4 DELTA 4 - SPRAB COMMENTS - 11/22/19
2 DELTA 2 - SPRAB COMMENTS - 09/09/19

PIERRE DELRAY I - SPRAB SITE PLAN APPLICATION

PIERRE DELRAY PHASE I - SPRAB SITE PLAN PACKAGE

A3

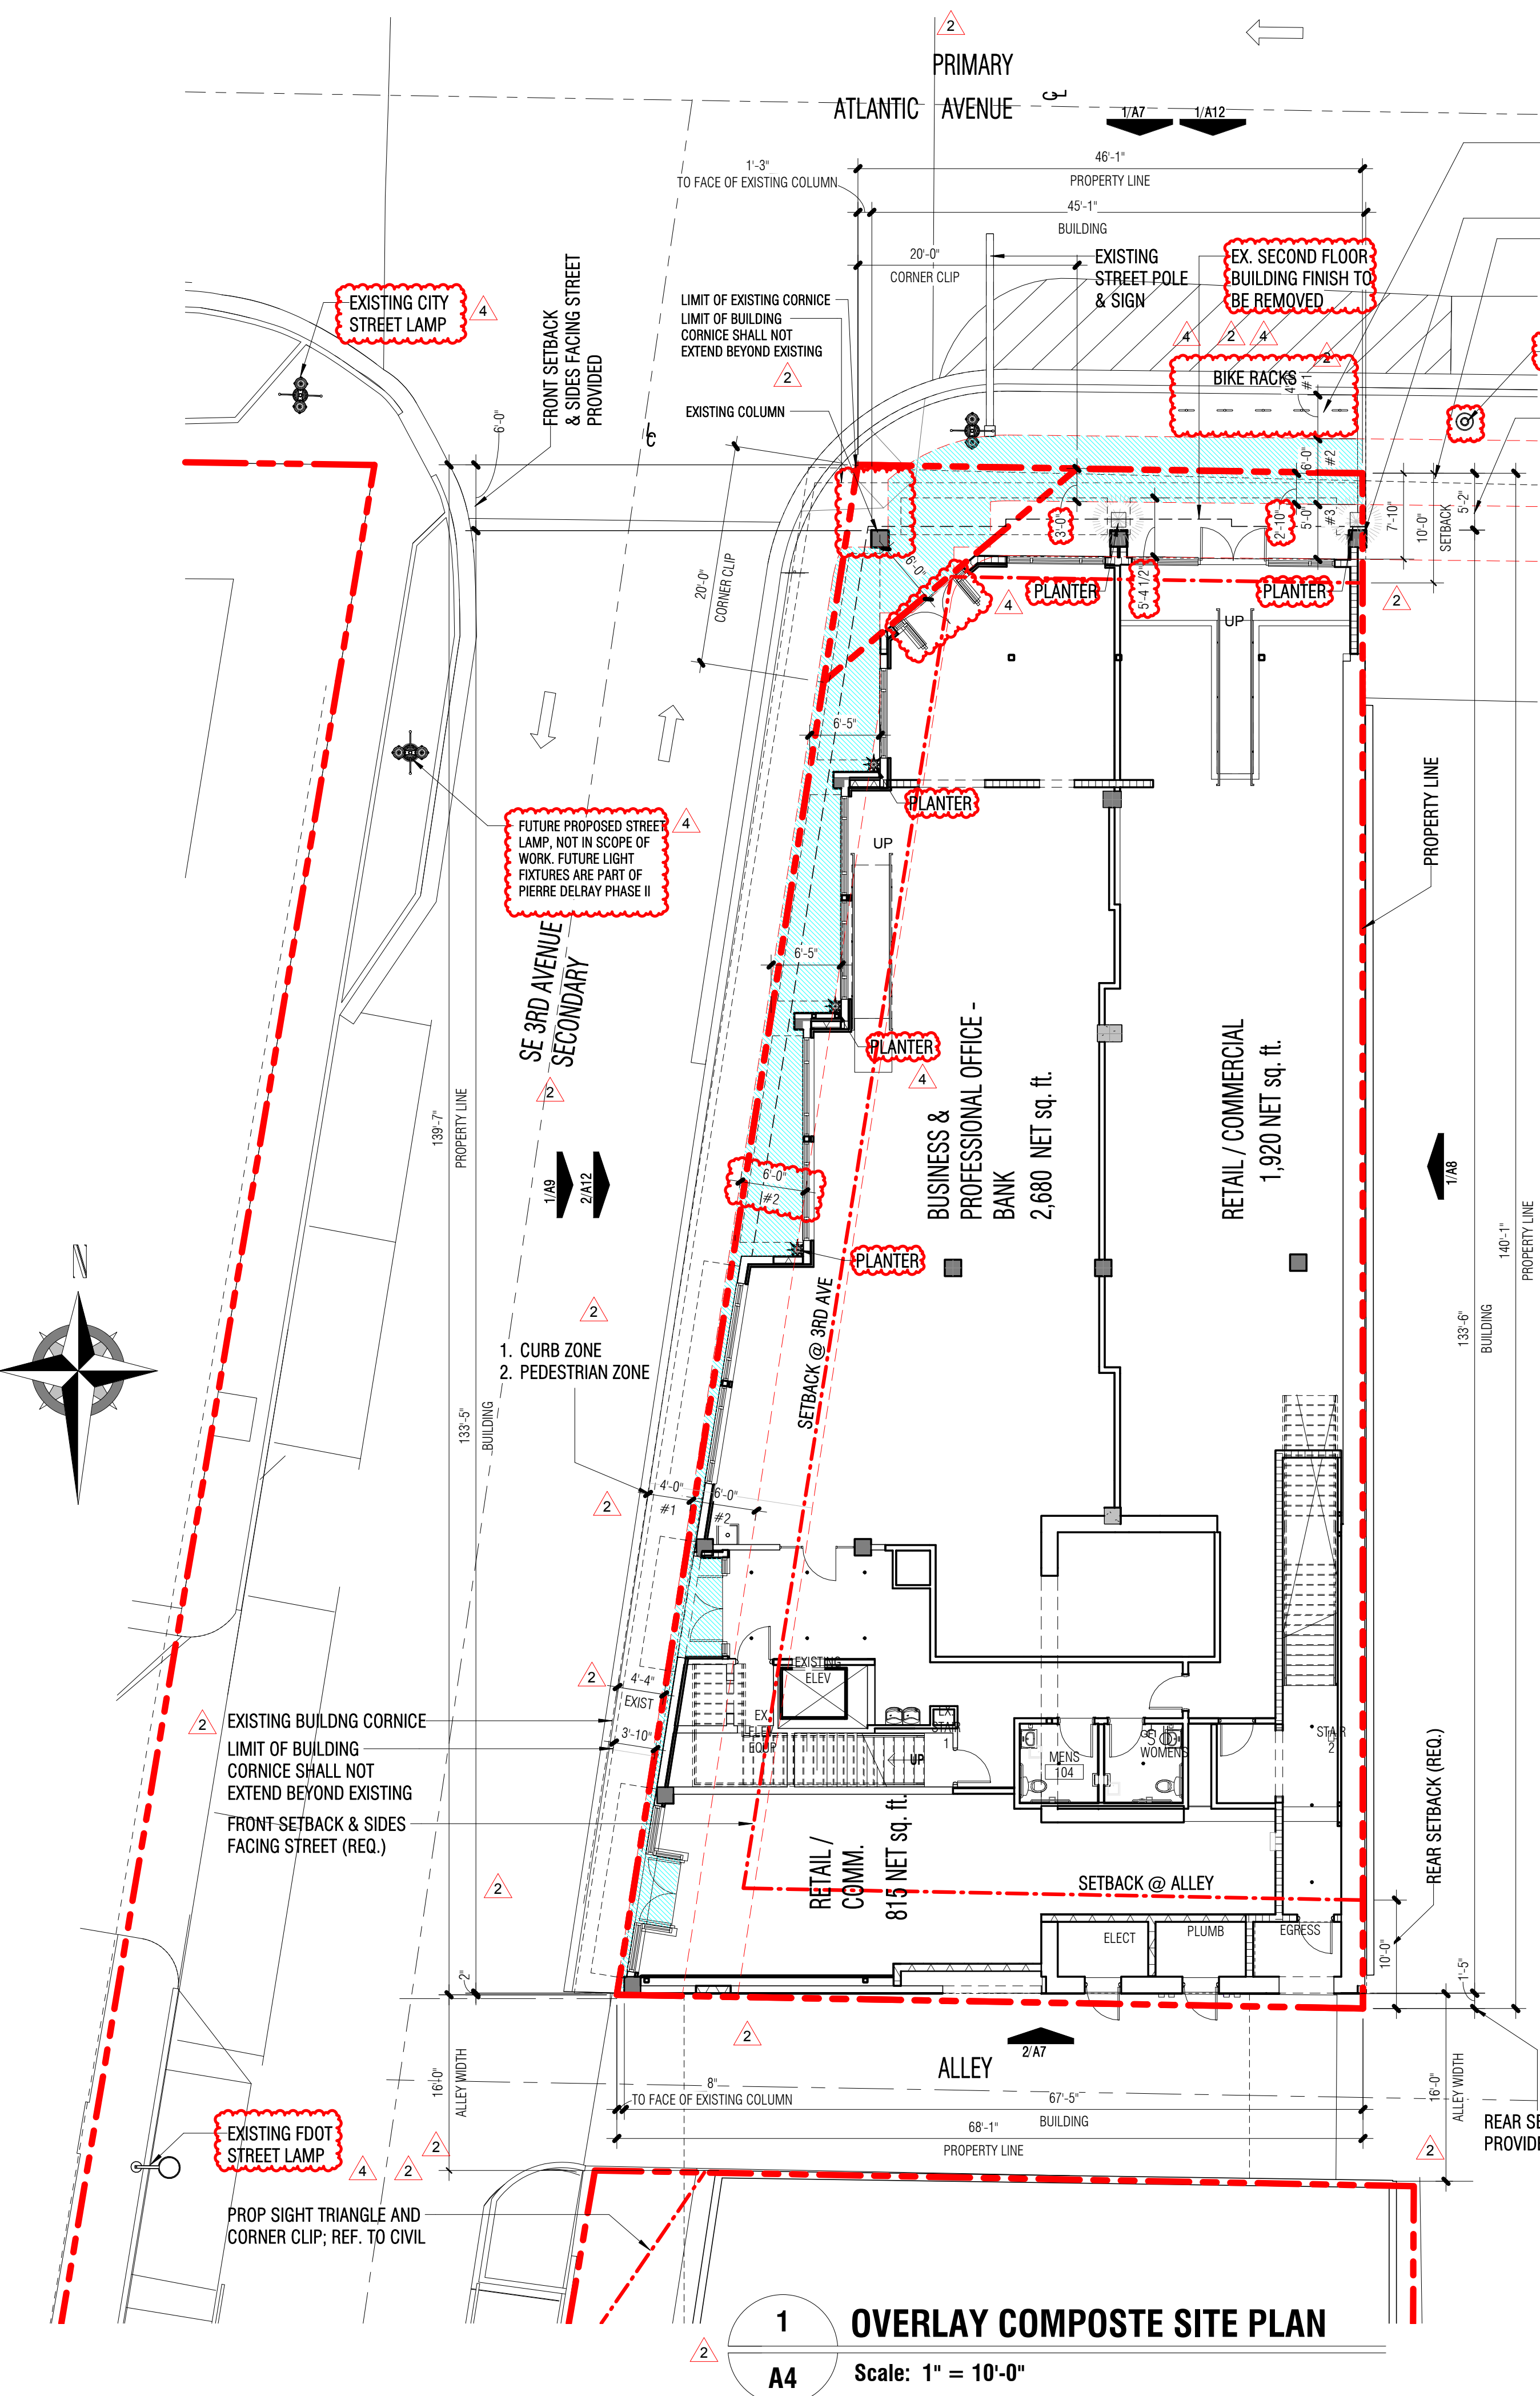
BIKE RACK
COMMENT #30

Pursuant to LDR Section 4.4.13(1)(4), Table 4.4.13 (M), Bicycle Parking Requirement, the minimum number of bicycle parking spaces for retail uses are 1 space per 1,000 sf, and for Professional Offices 1 space per 2,000 sf. The proposed building is 14,357 sq. ft. The gross square footage is composed of 2,771 sf of retail space, and 11,586 sf of business office space. As such, the retail square footage requires 3 spaces (2,771 sf / 1,000 sf), and the business office square footage requires 6 spaces (11,586 sf / 2,000 sf). As result, the project is required to provide 9 bicycle parking spaces. Please provide bicycle parking racks that can accommodate 9 bicycles. You can put the bicycle rack in the curb zone, but the rack has to be perpendicular to Atlantic Avenue so that the bicycles do not stick out into the pedestrian clear zone.

5 BIKE RACKS ARE PROVIDED TO PROVIDE A TOTAL OF 10 BICYCLE SPACES. RACKS ARE PERPENDICULAR TO STREET.
